JONES & BEACH ENGINEERS INC.

**RE: Response Letter 3 – Altus Engineering & TAC Comments
212, 214, & 216 Woodbury Ave., Portsmouth, NH, 03801
Tax Map 175, Lots 1, 2, & 3
JBE Project No. 21254**

We are in receipt of comments from Eric Weinrieb, P.E., Altus Engineering, dated October 25, 2022, and from Stefanie Casella, Portsmouth Planning Department, dated November 14, 2022. Review comments are listed below with our responses in bold.

DRAWING No.
W1
SHEET 1 OF 2
JBE PROJECT NO. 21254

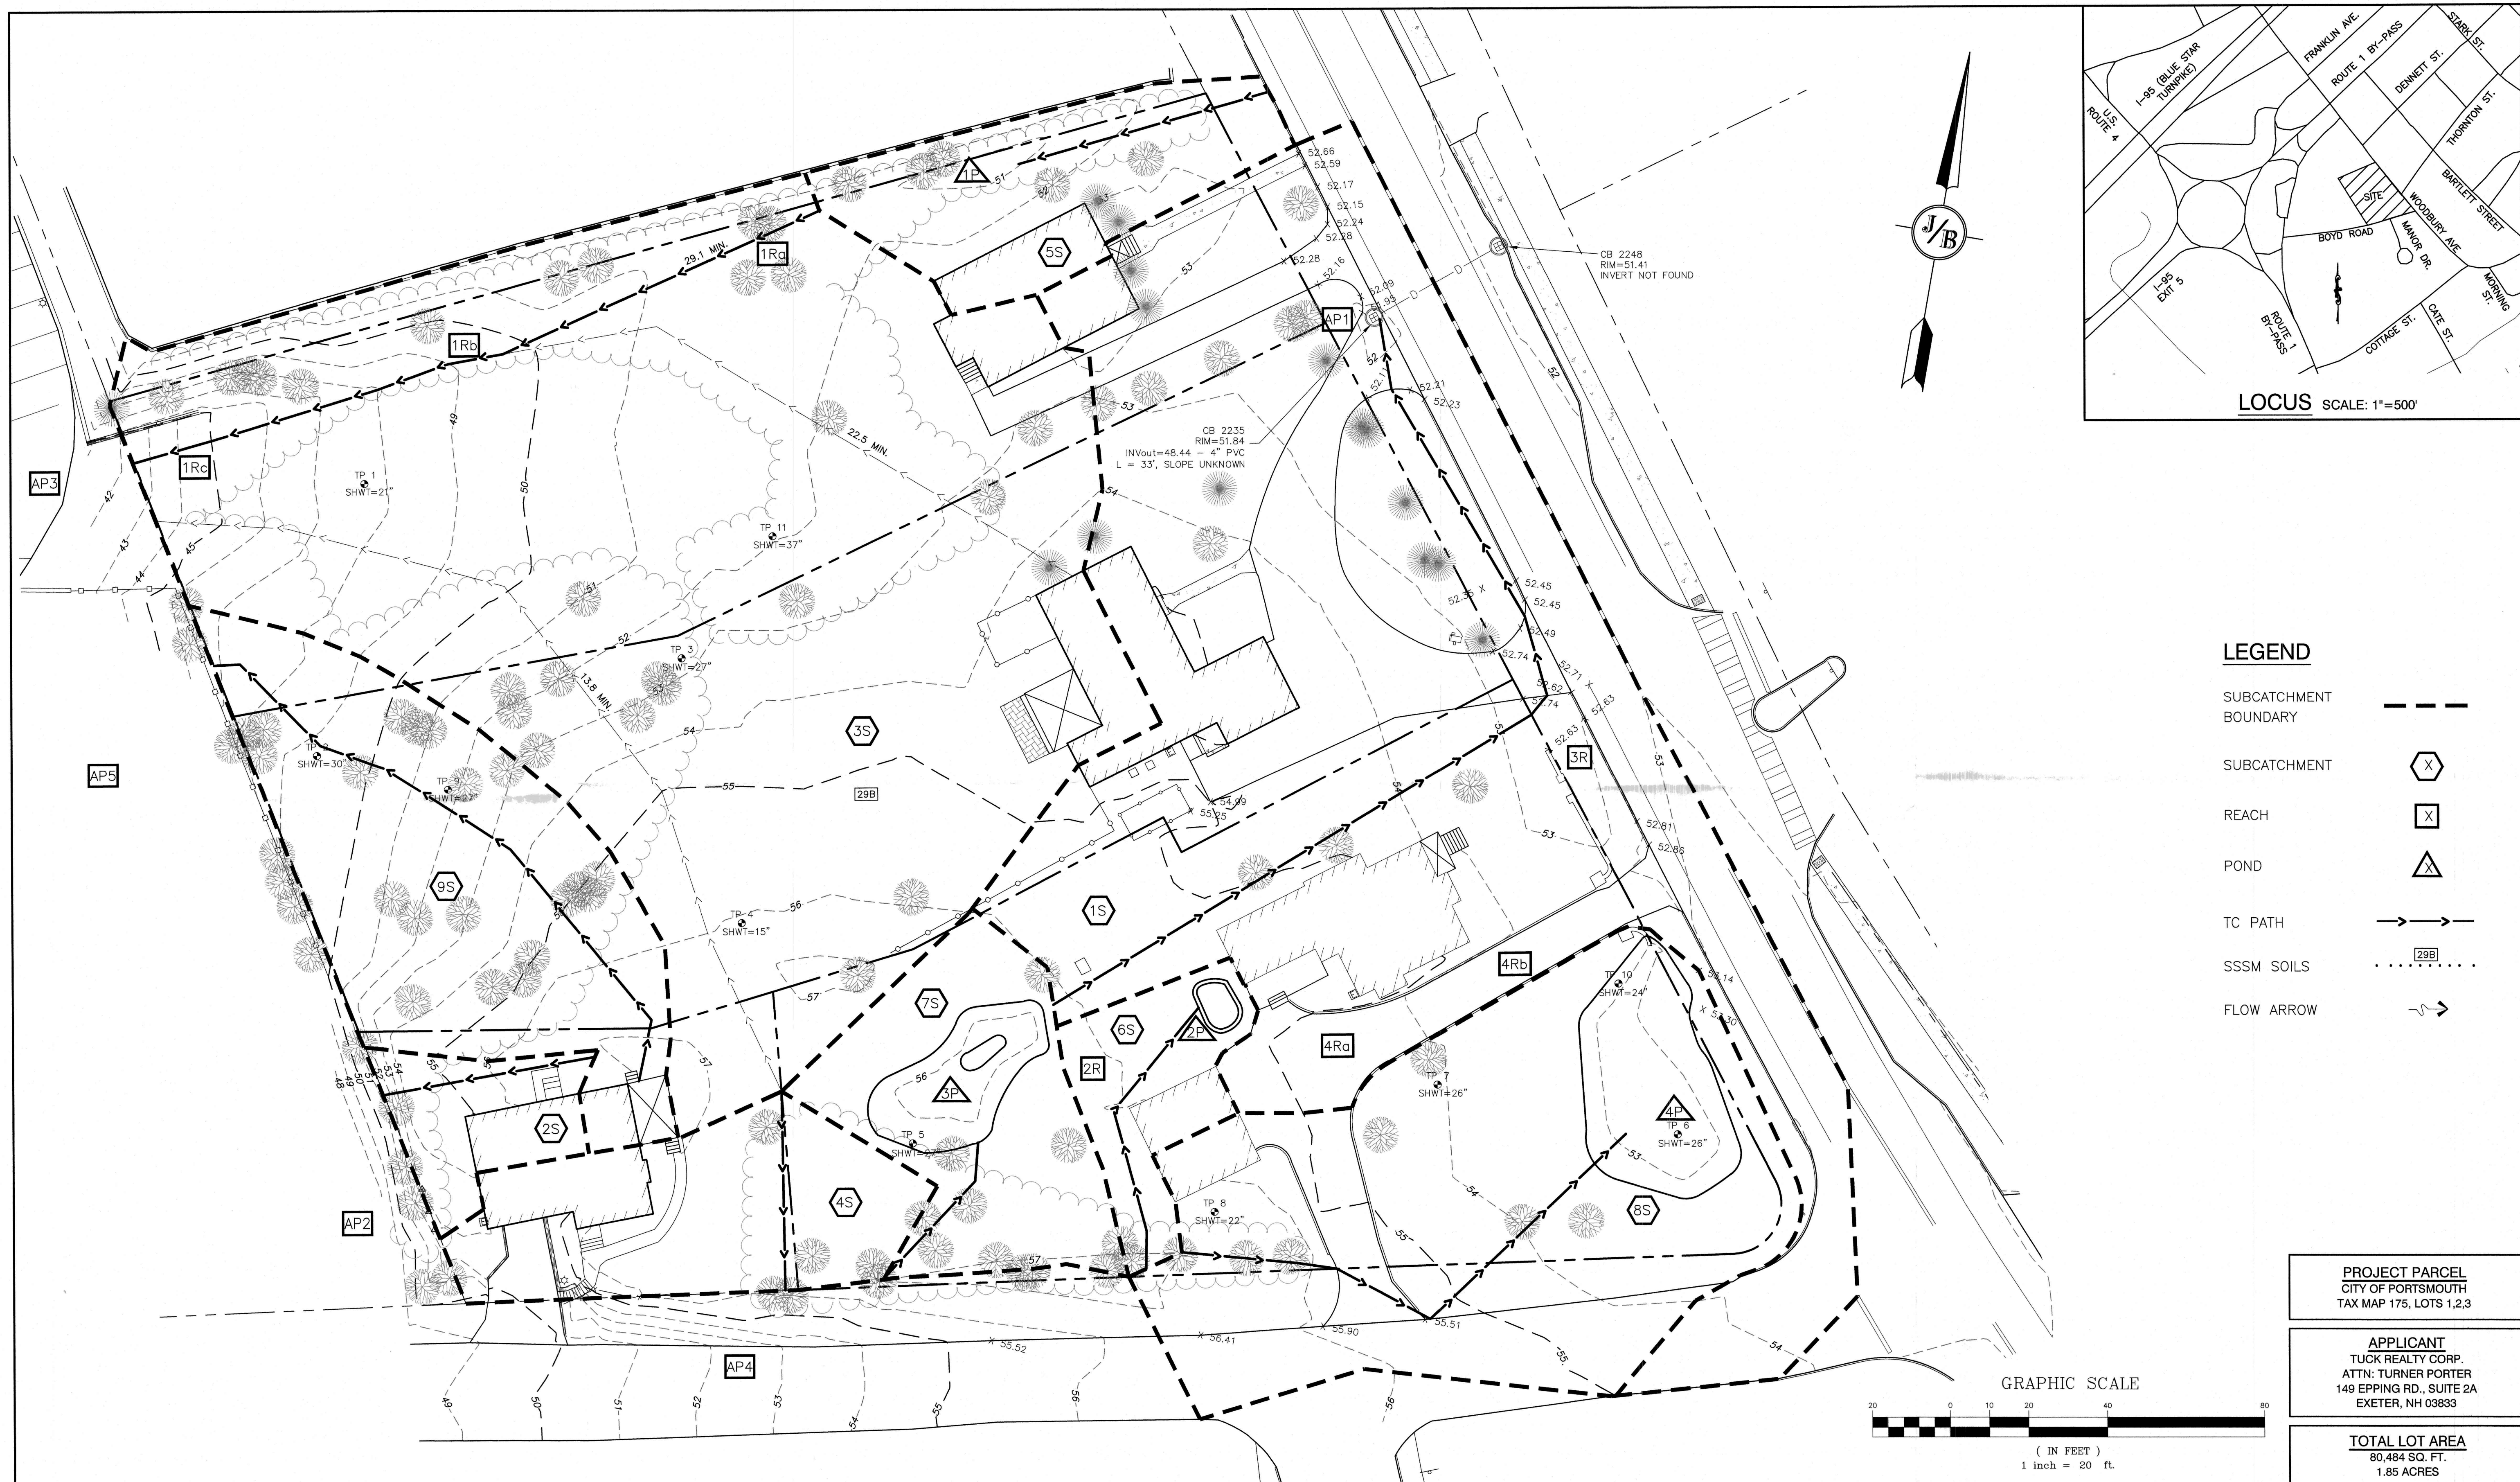
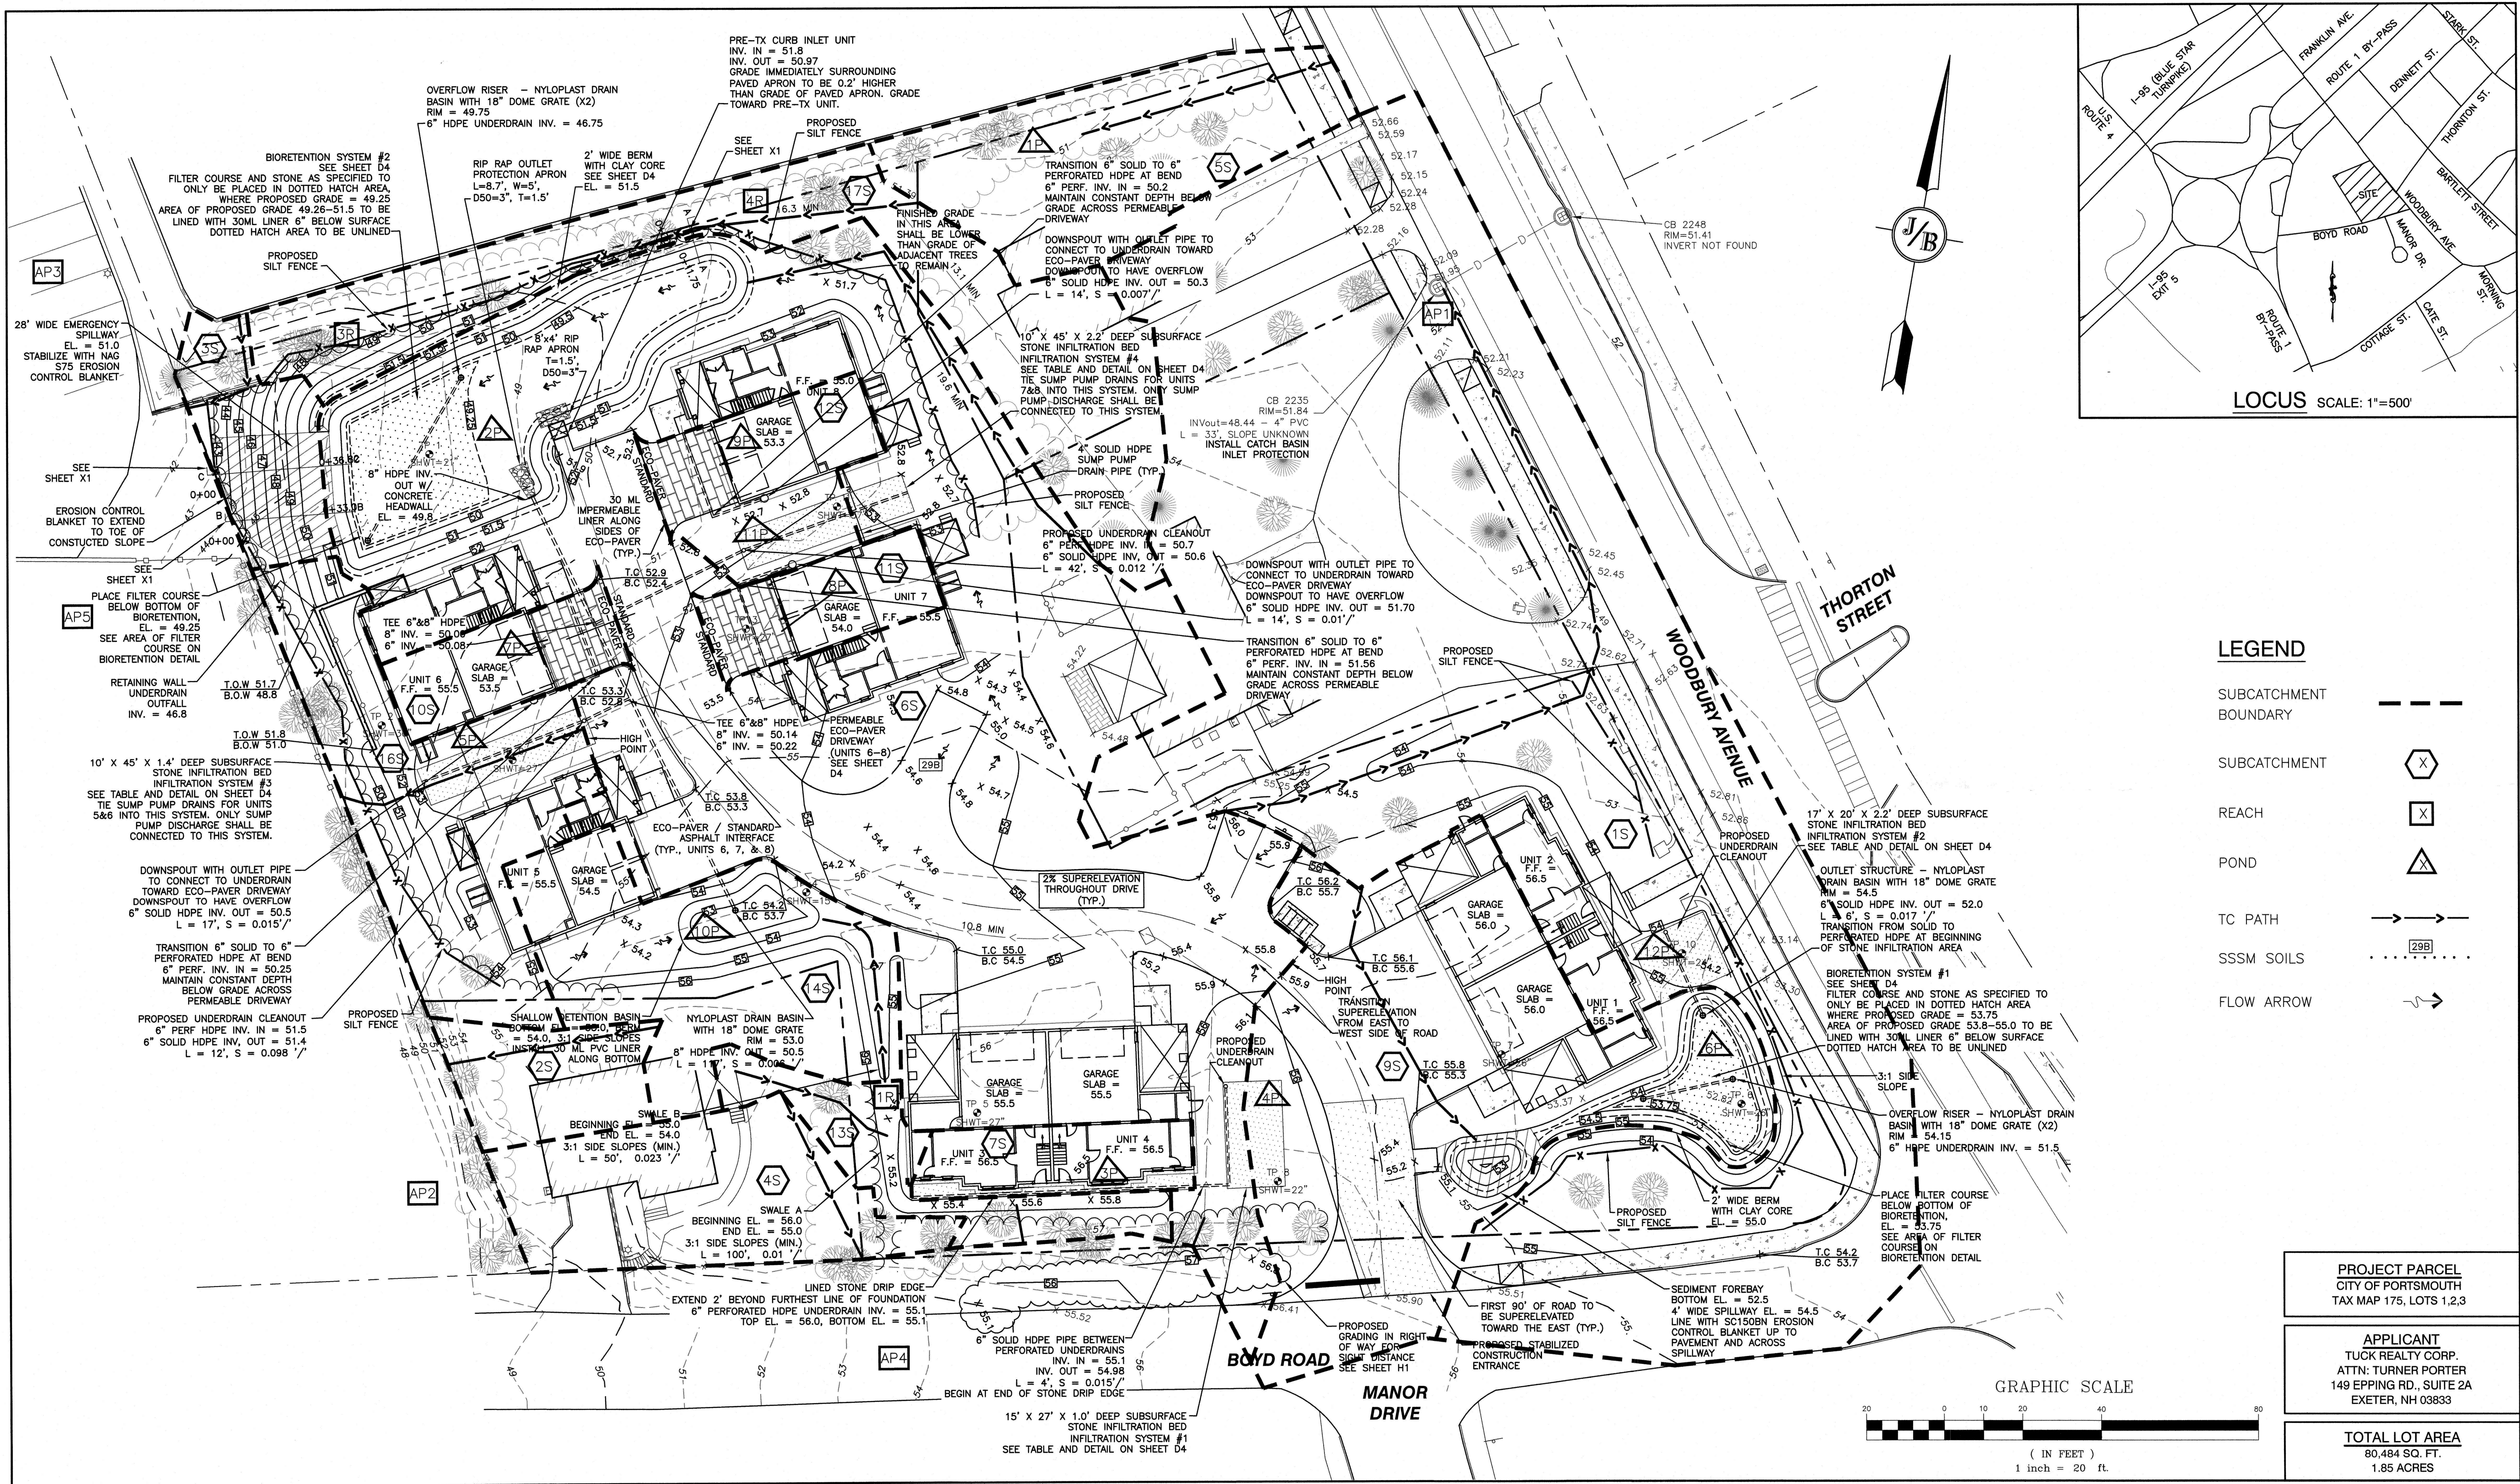
- e. *Post development subcatchment 6S indicates that longest flow path is 165-feet. The Designer should confirm the computation. The plans indicate that the subcatchment starts in Boyd Road and ends in Bioretention basin 2.*

RESPONSE: The proposed watershed plans indicate that the longest flow path begins at the corner of the house on lot 2 and ends at bioretention basin 2. This is hydraulically the longest flow path due to the preponderance of wooded area within the sheet flow segment. A flow path beginning at Boyd Road shows the wooded area in the shallow concentrated flow segment and therefore results in a shorter time of concentration. The two different Tc paths with their lengths in minutes have been added to the plans for reference.

DRAWING No.
DM-1
SHEET 3 OF 23
JBE PROJECT NO. 21254

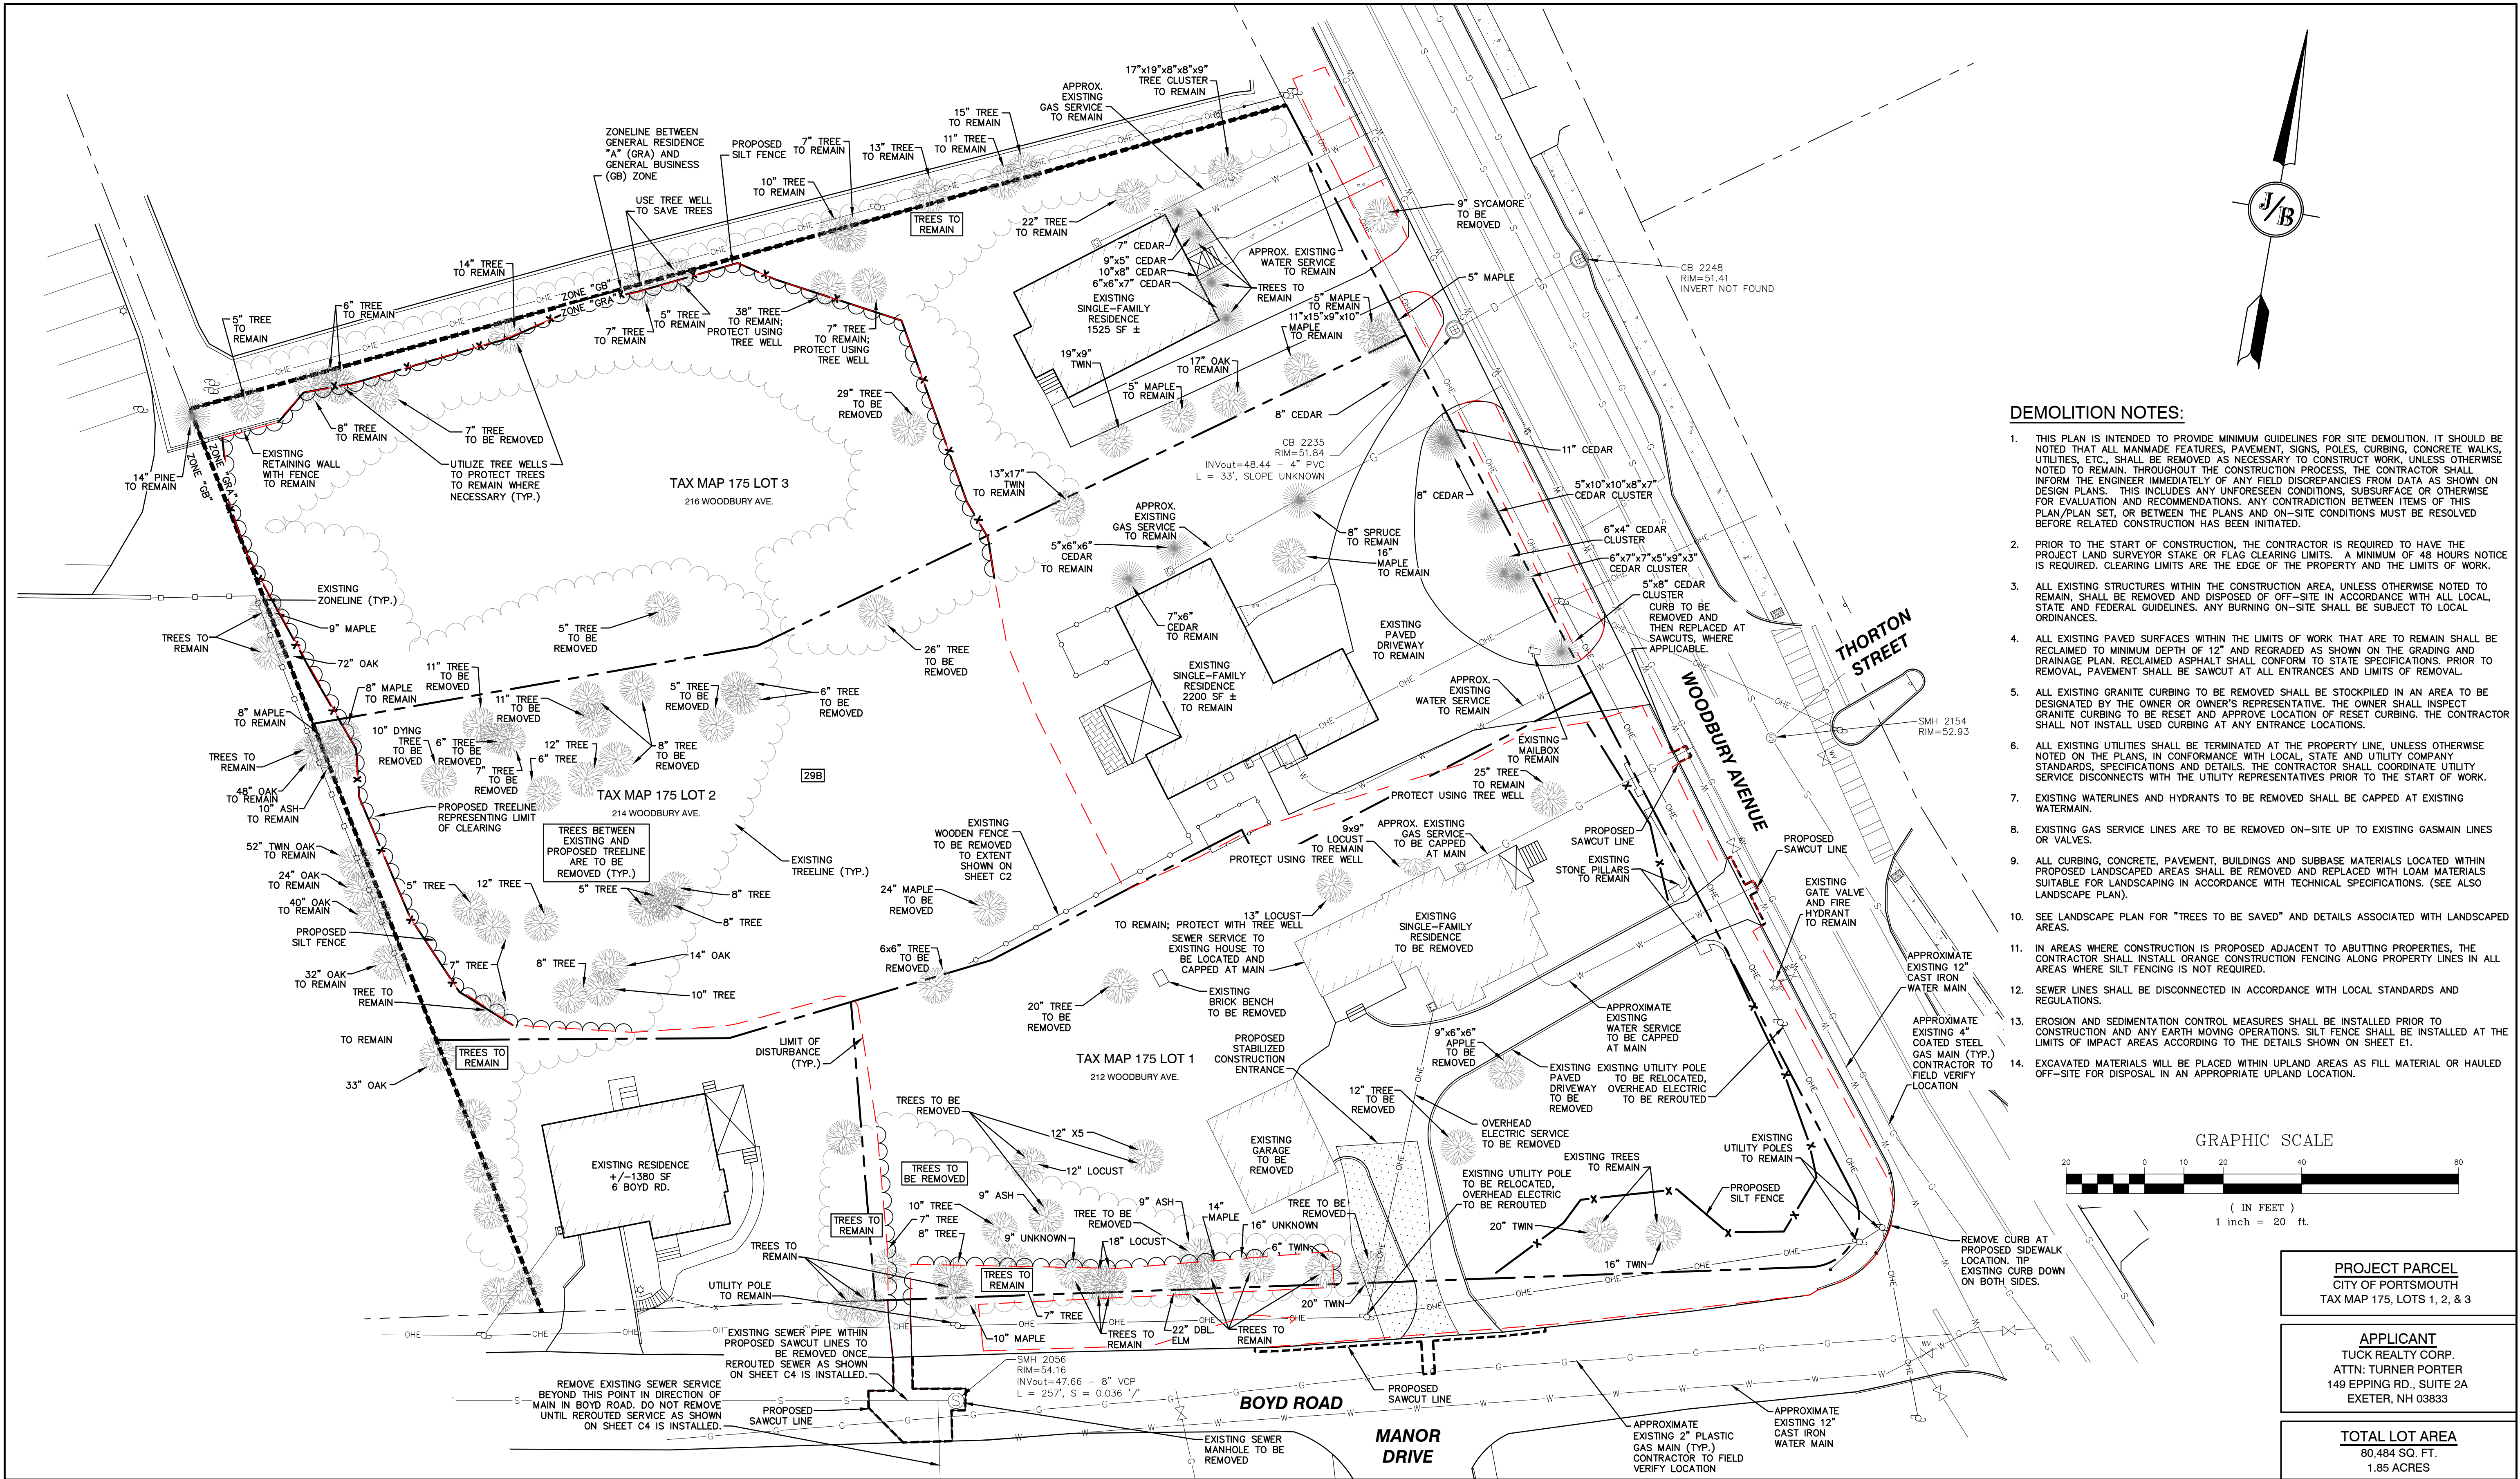
2. *He should add identification for existing trees to remain.*

RESPONSE: Sheet DM-1 now includes every tree on the lot with designations of which ones are to remain and which are to be removed.
